**Project: 665 John Knox Village Courtyards - Bldg E**  
515 NW Moore St  
Lee's Summit, Missouri 64081

## Submittal #02.0 - 051200-02 Shop Drawings 051200 - STRUCTURAL STEEL FRAMING

Comm. No. 23104.00

ERECTION PLANS &amp; DETAIL SHEETS

| WELD:<br><b>E70XX</b>                           | TITLE: <b>ROOF FRAMING PLAN</b>                                                  |

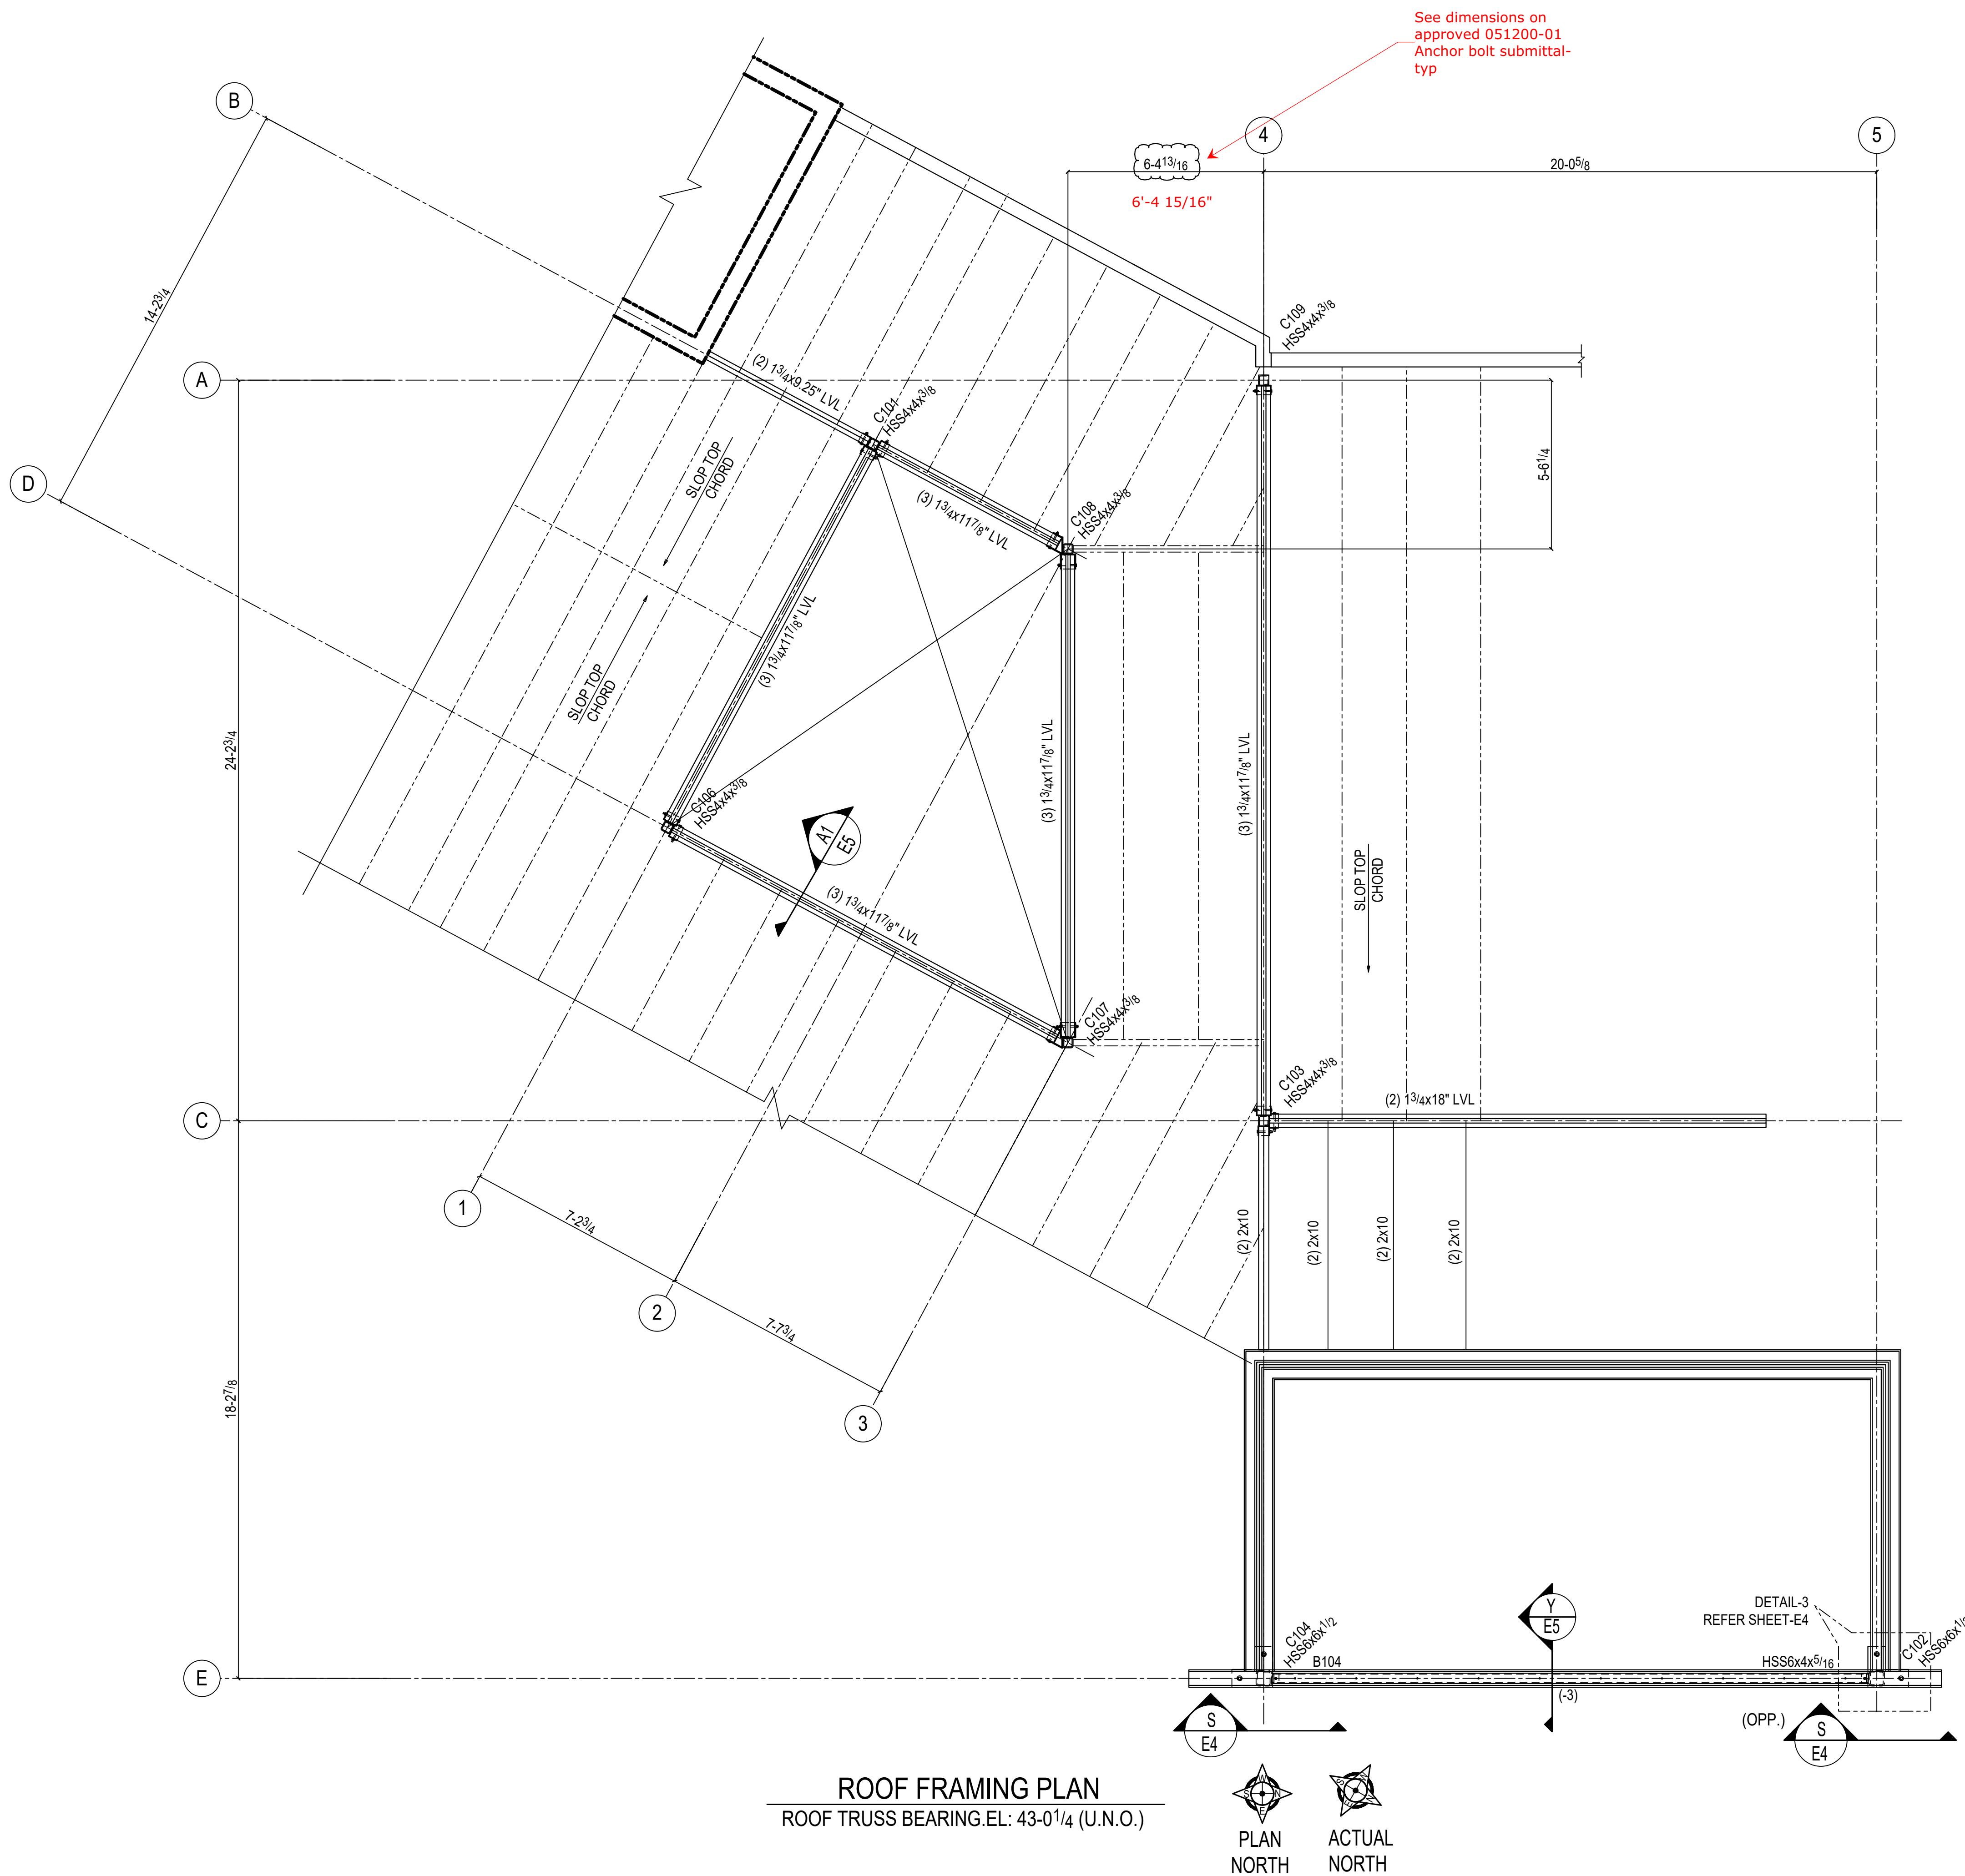
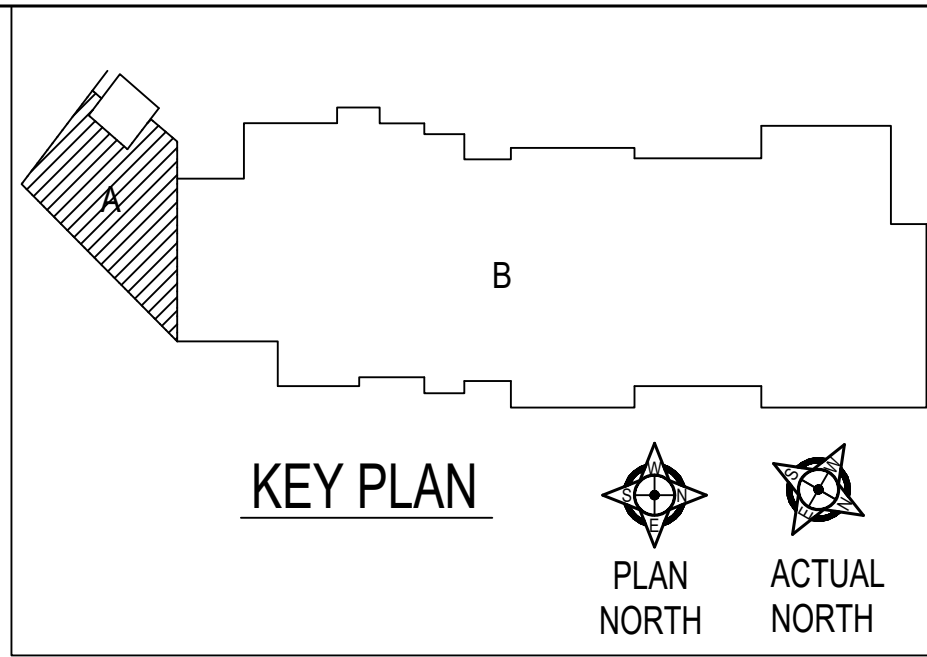
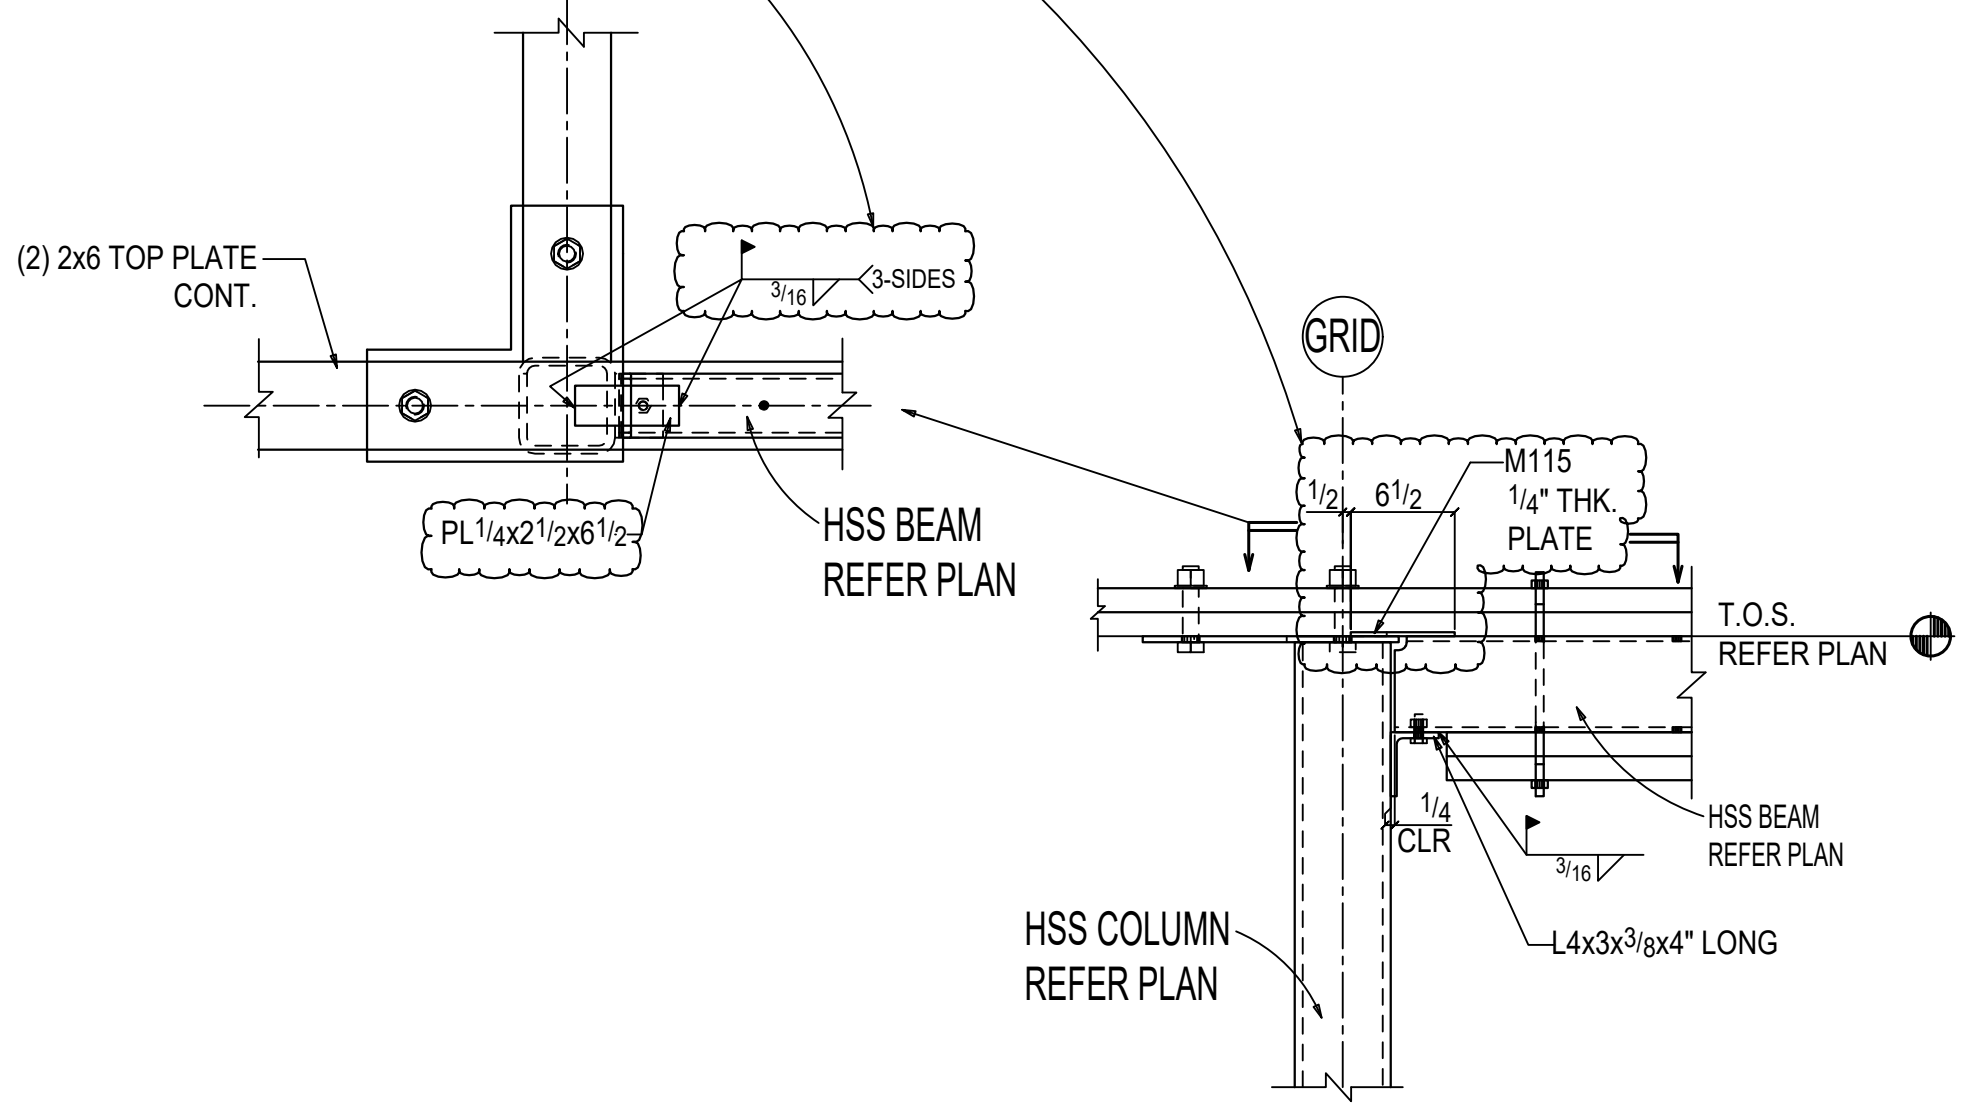
APPROVER, PLEASE VERIFY THE BEAM TOP CONNECTION. ACCORDING TO SECTION 6/S3.2, WE ARE REQUIRED TO PROVIDE AN HSS BEAM TO HSS COLUMN SEATED CONNECTION. HOWEVER, AT THE ROOF LEVEL, AS PER DETAIL 13/S3.3, THEY HAVE SHOWN A 3/8" CAP PLATE CONNECTION. DUE TO THIS, WE CAN ONLY ADD ONE ANGLE AT THE BOTTOM OF THE HSS BEAM. SO, INSTEAD OF A TOP ANGLE, WE ARE USING A 1/4" PLATE AT THE TOP OF THE CAP PLATE.

Approved.

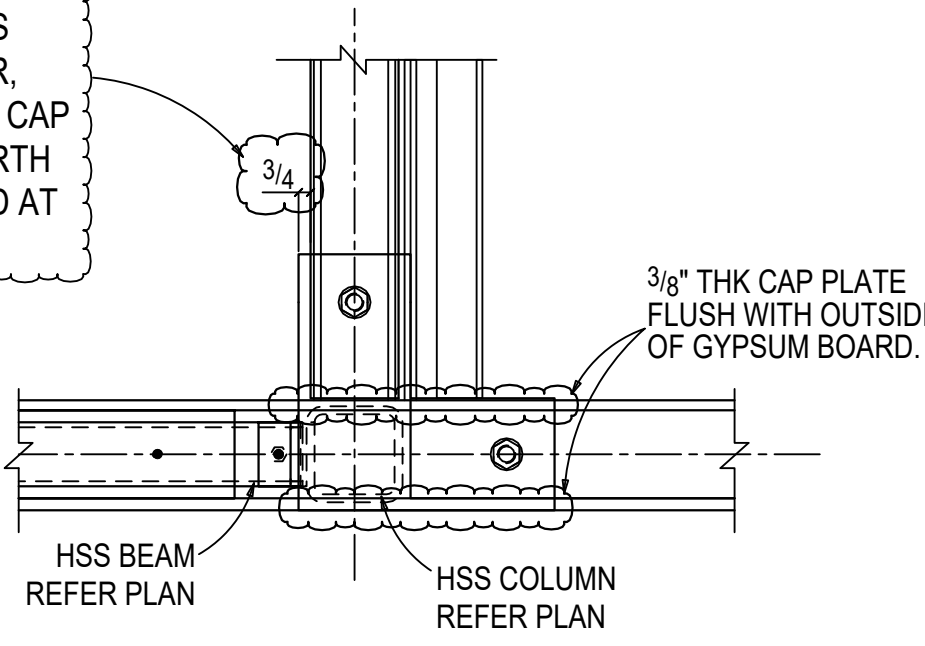
"APPROVER, PLEASE VERIFY AT THE CLOUDED LOCATION AS PER SECTION 13/S3.3, WE HAVE PROVIDED A 3/8" THICK CAP PLATE THAT IS 1/2" WIDER THAN THE HSS TUBE. HOWEVER, BASED ON THE FRAMING CONDITION, THE CAP PLATE PROTRUDES BY 3/4" FROM THE NORTH SIDE WALL AND CUTS THE GYPSUM BOARD AT THE EAST & WEST SIDE OF THE WALL.

Reduce plate to match wall stud depths

## 47 BRACKETS M113

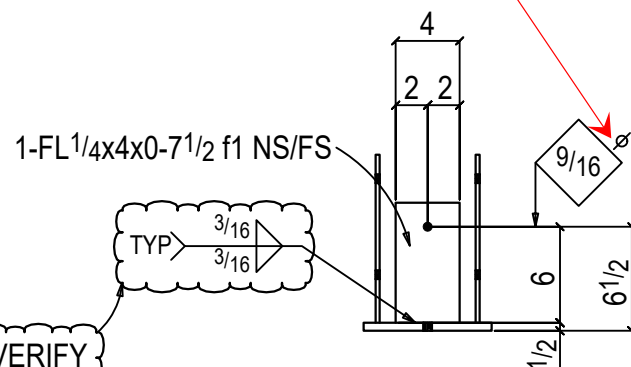
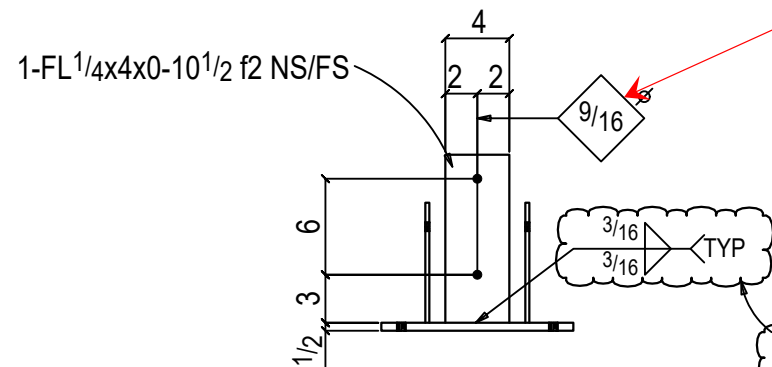
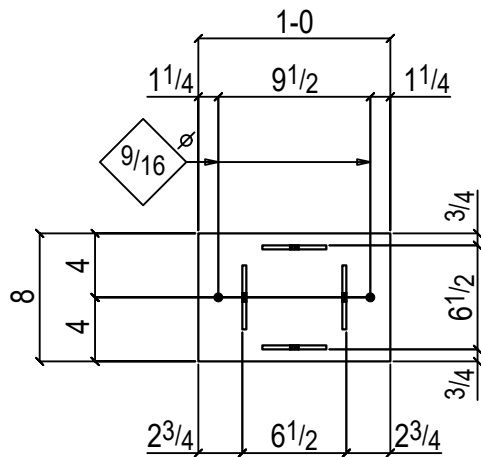
APPROVER, PLEASE VERIFY  
CLOUDED WELDS.
